Millstone Nuclear Power Station, Unit No. 3
Transmittal of Responses to the SER Open Items

Responses to SER Open Items

Millstone Unit No. 3
SER OPEN ITEMS
EQUIPMENT QUALIFICATION BRANCH

TOP VIEW OF SCES*IPNL122
WITH JUNCTION BOX INSTALLED

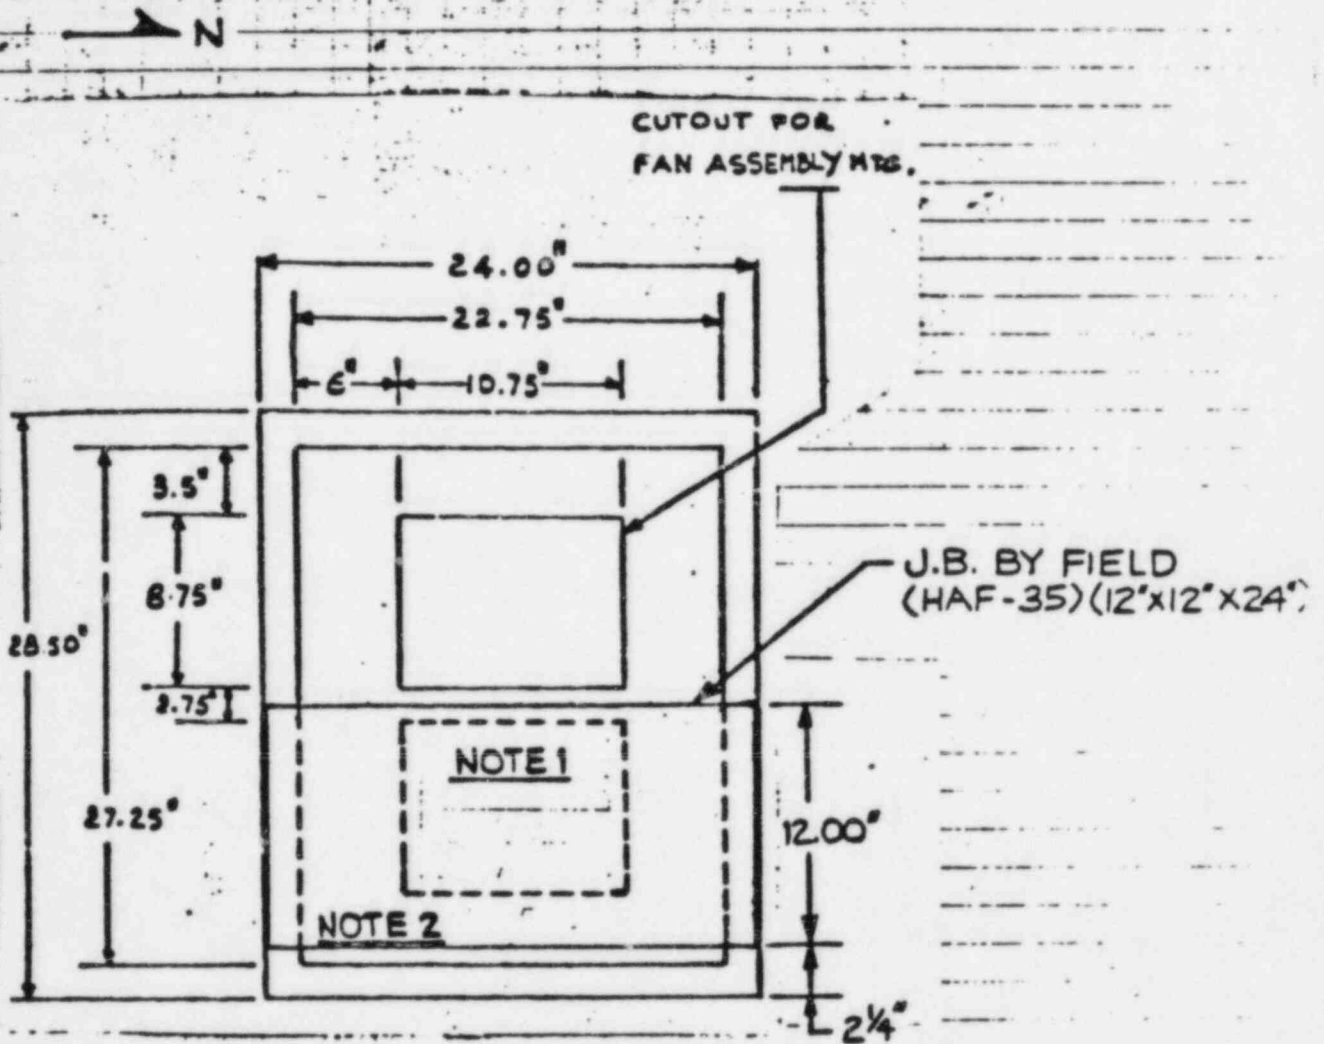
- 1) TO CLEAR THE INTERFERENCES, THE FIELD SHALL MODIFY THE JUNCTION BOX FLANGES AND RELOCATE THE ANCHOR BOLTS AS SHOWN ON PAGE 5 OF THIS E&DCR. FOR ADDITIONAL INFORMATION REFER TO PAGE 4 OF THIS E&DCR.
- 2) ORIGINAL PROBLEM SOLUTION AS FOLLOWS: TO FACILITATE CONDUIT INSTALLATION INTO 3CES*IPNL122, THE FIELD SHALL ATTACH JUNCTION BOX HAF-35 TO PANEL PER DETAIL ON PAGE 3&5. STRUCTURAL INTEGRITY OF PANEL ANCHORAGE TO FLOOR IS MAINTAINED. REF. CALC. NO. 12179/SEO-C10.25 (CONTINUED ON PAGE 7)

- 1) REFER TO PAGE 3 OF THIS E&DCR FOR CONNECTOR PLATE MODIFICATION DETAILS.
- 2) REFER TO PAGE 4 OF THIS E&DCR FOR JUNCTION BOX CUT-OUT DETAILS.

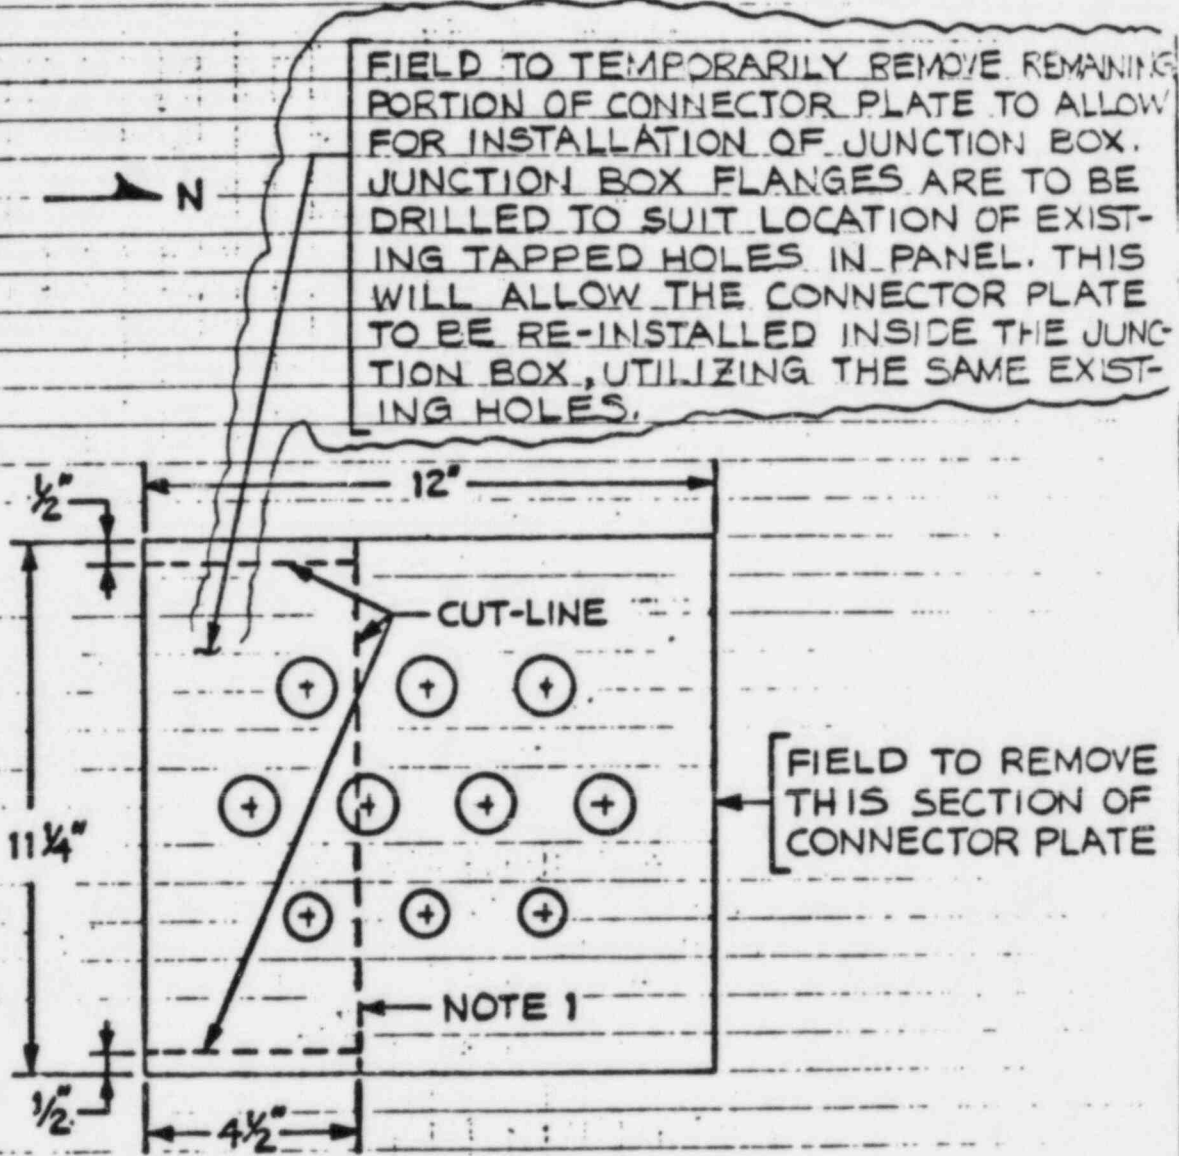
FIELD TO TEMPORARILY REMOVE REMAINING PORTION OF CONNECTOR PLATE TO ALLOW FOR INSTALLATION OF JUNCTION BOX. JUNCTION BOX FLANGES ARE TO BE DRILLED TO SUIT LOCATION OF EXISTING TAPPED HOLES IN PANEL. THIS WILL ALLOW THE CONNECTOR PLATE TO BE RE-INSTALLED INSIDE THE JUNCTION BOX, UTILIZING THE SAME EXISTING HOLES.

FIELD TO REMOVE THIS SECTION OF CONNECTOR PLATE

FIELD JUNCTION BOX CUT-OUT DETAILS
(LOOKING AT BOTTOM OF BOX)

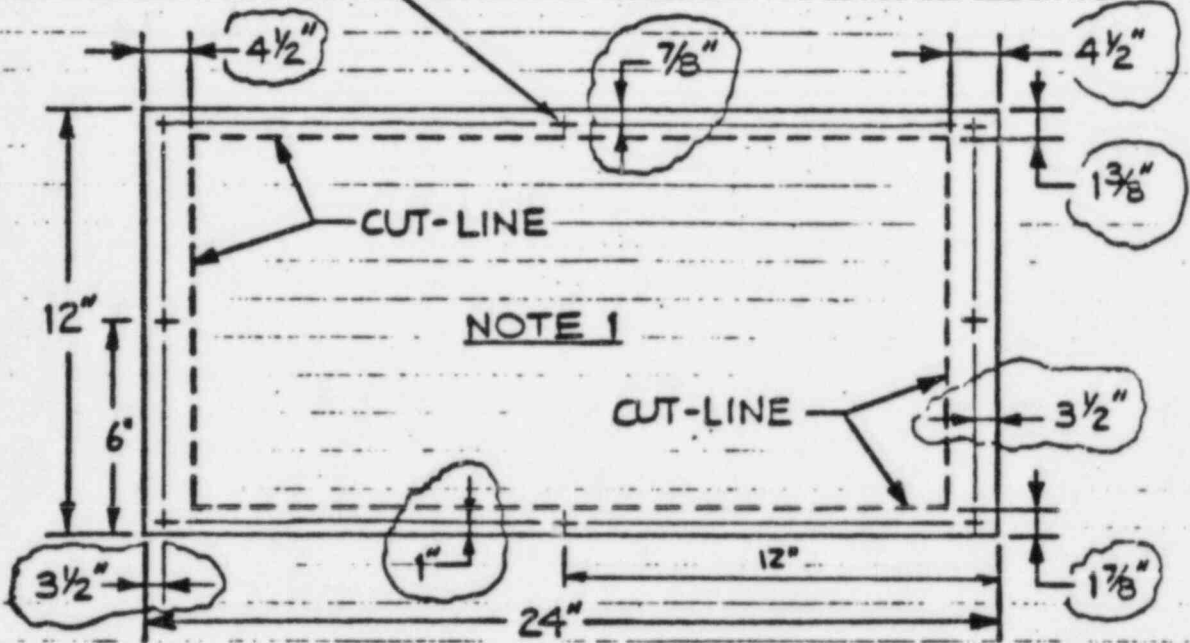
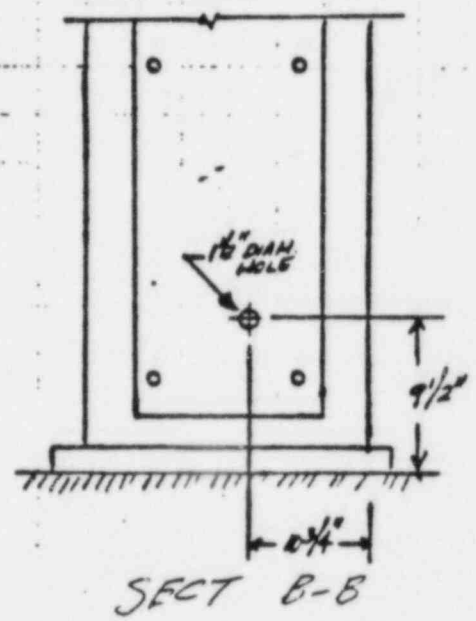
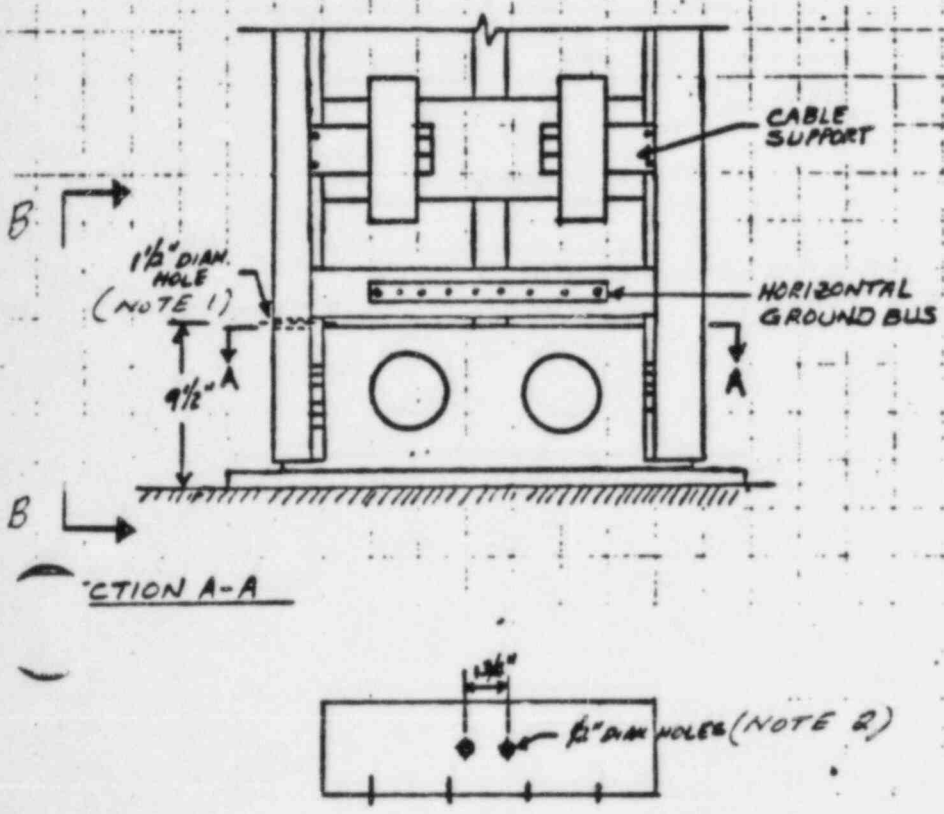
ATTACH JUNCTION BOX TO PANEL USING $\frac{1}{4}$ " ϕ HEX HEAD SCREW & NUT PER SPEC E350, L_A TO SUIT. LOCATE AT CORNERS & 1 PER SIDE, AS SHOWN (TOTAL OF 8 SCREWS).

- 1) FIELD TO CUT BOTTOM OF JUNCTION BOX IN ACCORDANCE WITH DIMENSIONS GIVEN.
- 2) FIELD TO PROVIDE PROTECTIVE EDGE DRESSING OR GROMMET AS NECESSARY.
- 3) FIELD TO INSTALL GASKET BETWEEN JUNCTION BOX AND 3CES*IPNL122. SIZE GASKET TO FLANGE DIMENSIONS AFTER CUT-OUT HAS BEEN REMOVED.

3HVR PNL-FLT-1A/B (CONTROL UNIT) (LOCATED ON WALL ABOUT EL. 66'-6")
 MOUNTED ON CONCRETE WALL
 N.T.S.

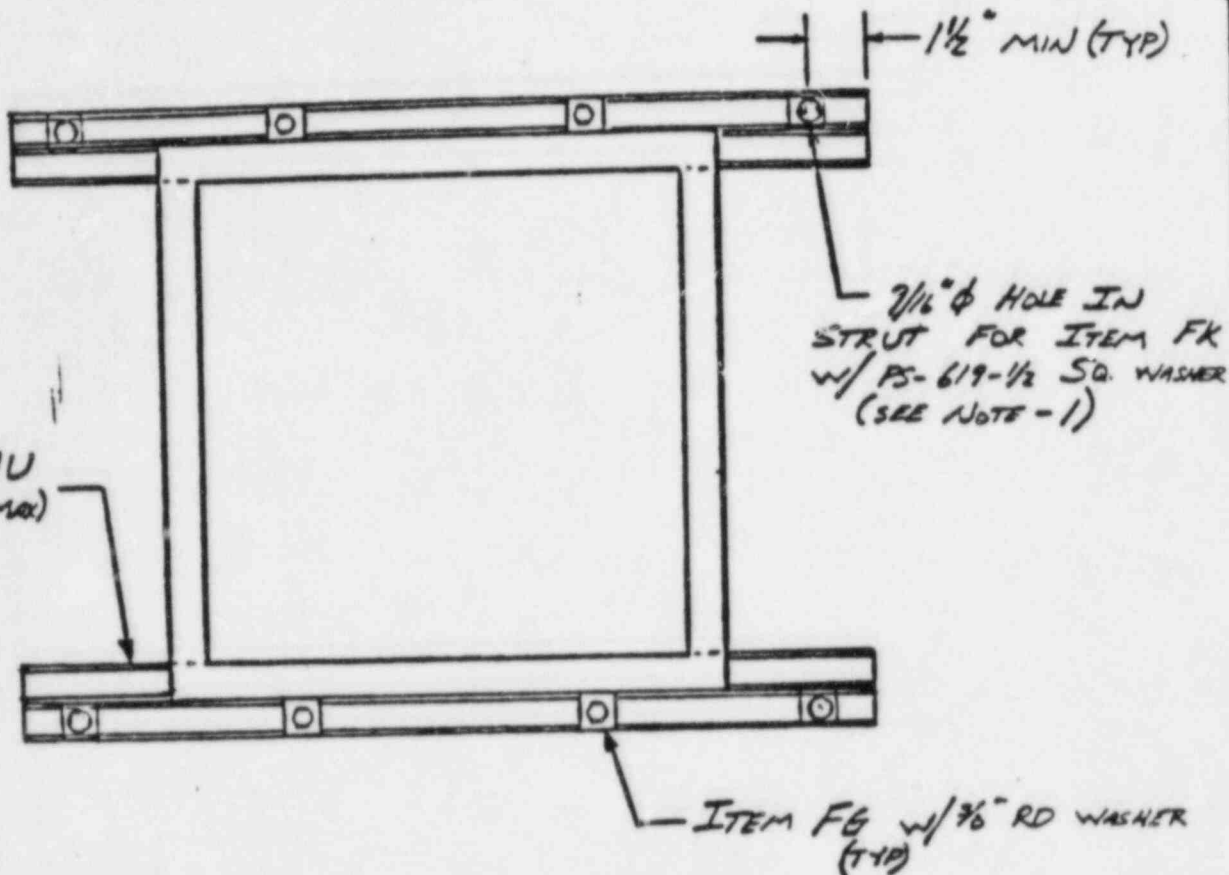
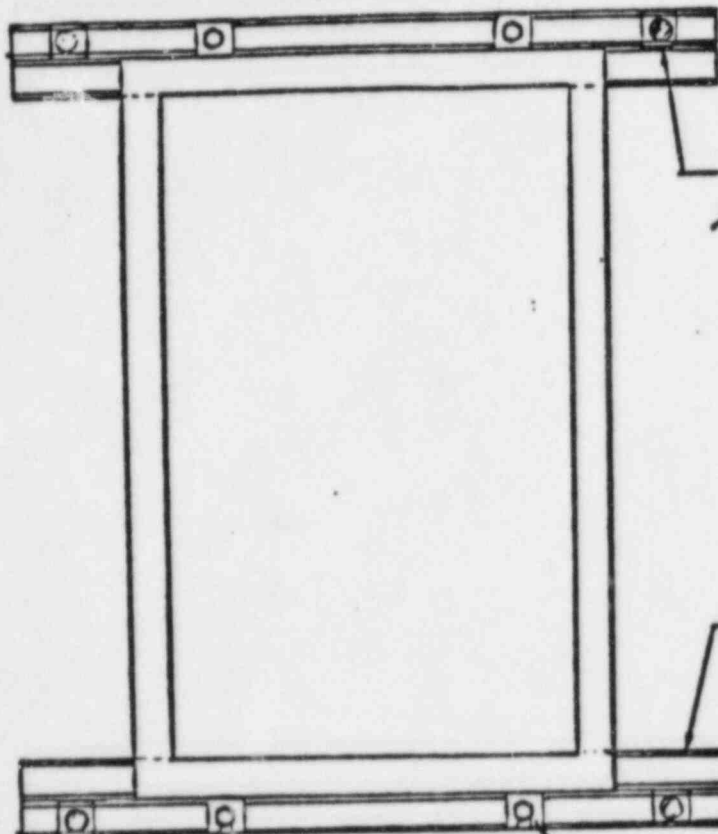
- 1.) THE $\frac{1}{2}$ " ϕ HILTI BOLT MAY BE LOCATED IN EITHER CHANNEL OF THE PS-202 STRUT.
- 2.) THE STRUT MAY BE ROTATED 90° TO SUT FIELD CONDITIONS.
- 3.) LOCATION & ELEVATION OF PNL ON CONCRETE WALL BY FIELD.

3HR * PNL-FIT-3A/B
MOUNTED ON CONCRETE WALL
N.T.S.

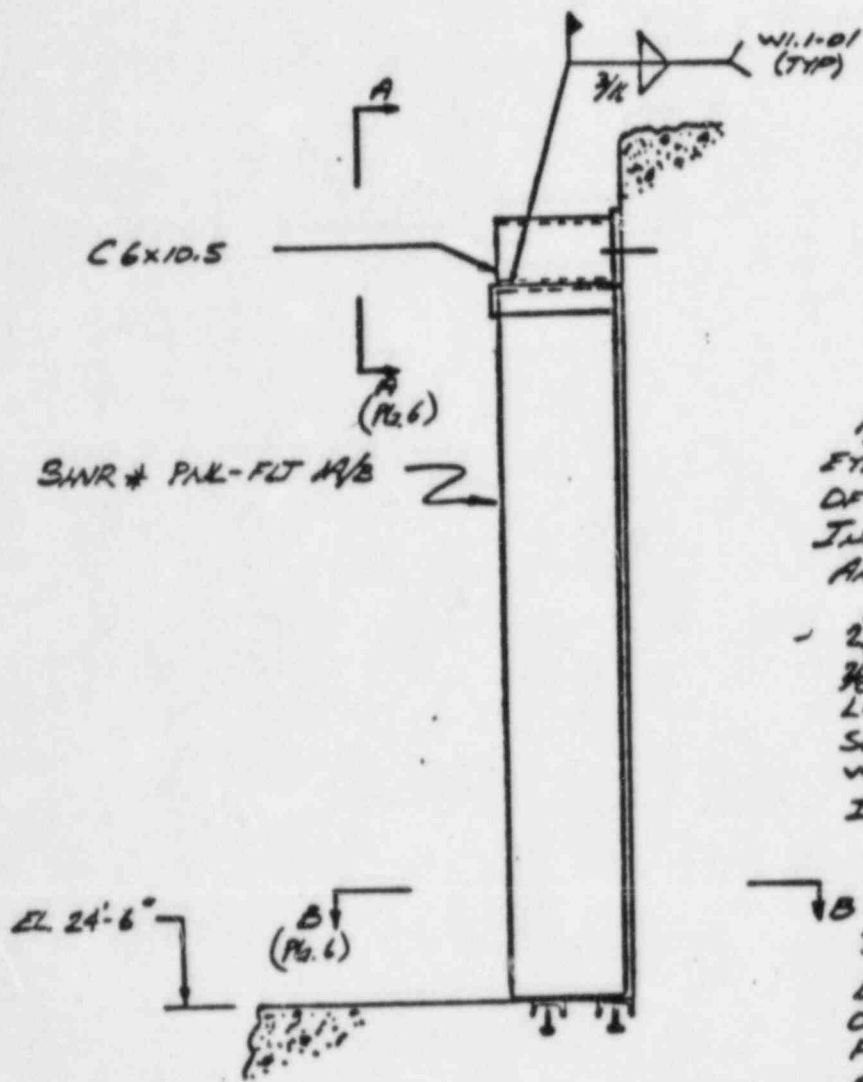
1/4" ϕ HOLE IN STRUT
FOR ITEM FK
W/ PS-619-1/2 SQ. WANNER
(SEE NOTE 1)

MITERED CORNER AND WELD DETAIL

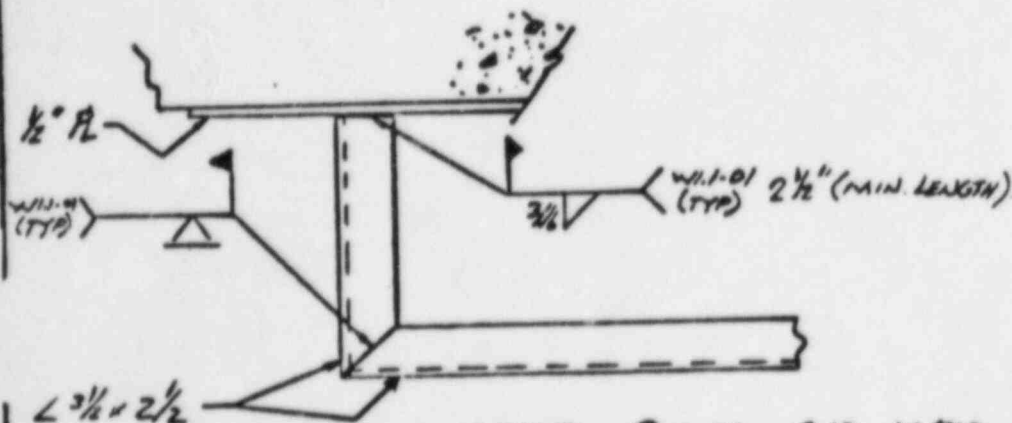
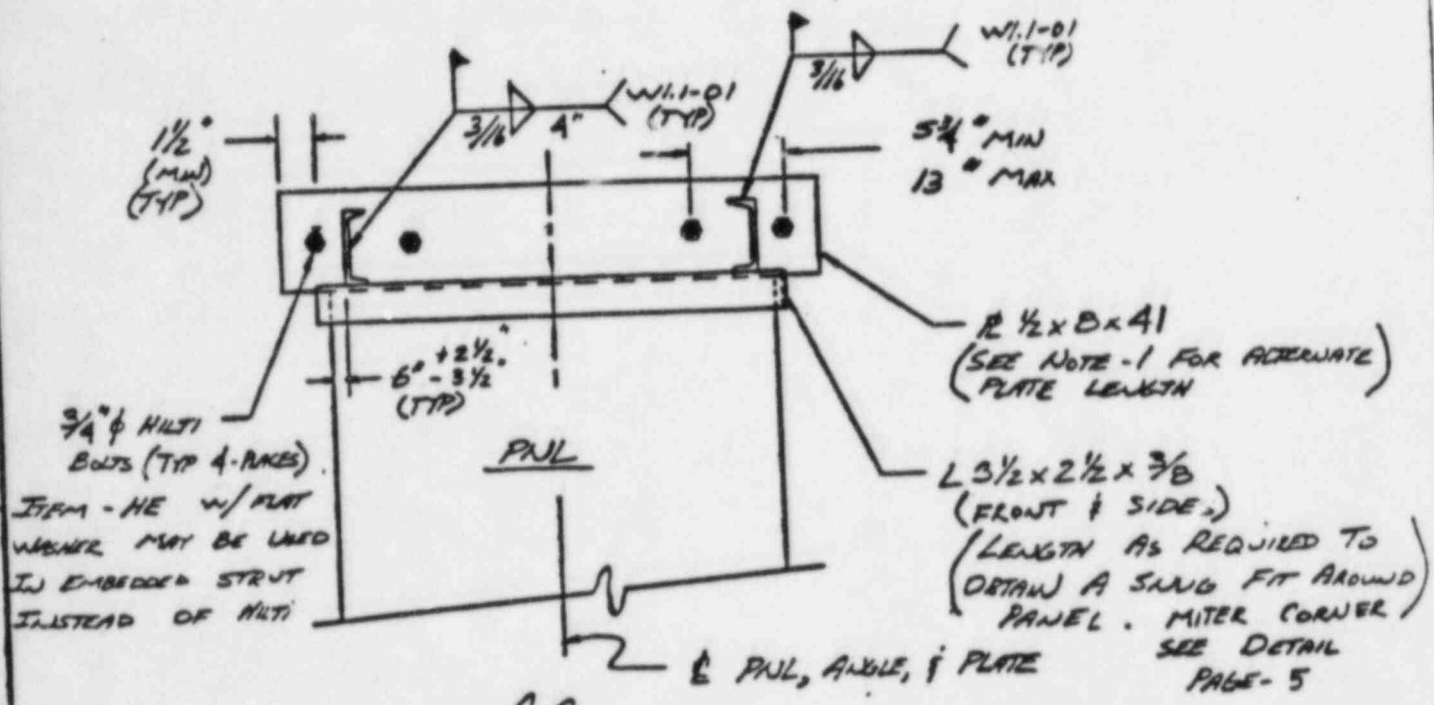
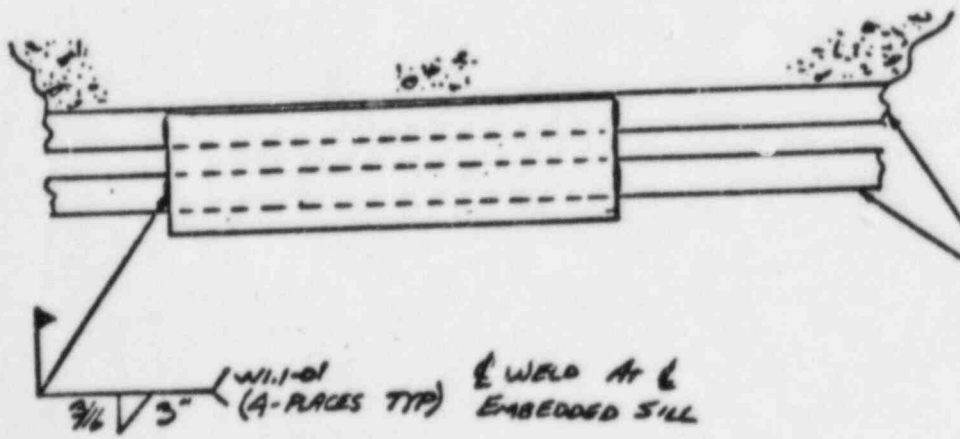
- 1) REMOVE THE LIFTING EYE BOLTS AT THE TOP OF THE PANELS FOR THE INSTALLATION OF THE ANGLE FRAME.
- 2) TAP THE EXISTING HOLES TO $\frac{3}{16}$ " ϕ , AND PROVIDE A $\frac{3}{16}$ " ϕ BOLT W/ LOCK WASHER. BOLT LENGTH TO SUIT SO BOLT WILL BE FLUSH WITH THE TOP OF THE PNL, INSERT BOLT FROM BOTTOM.
- 3) SINCE PNLS WILL BE LOCATED ADJACENT TO EACH OTHER, THE LT. GREEN FINISH COAT MAY BE APPLIED BEFORE FINAL INSTALLATION. ONLY PAINT THE TWO ADJACENT SURFACES. PRIOR TO INSTALLATION, REF. SPECS. 065 & C956

THE 1/2" R MAY BE CONTINUOUS BETWEEN THE TWO PANELS (90" LONG MAX), IF THEY ARE LOCATED ADJACENT TO EACH OTHER. THE BOLTING PATTERN SHOWN IS TYPICAL FOR EACH PANEL. MIN NUT/BOLT SPACING SHALL BE MAINTAINED.
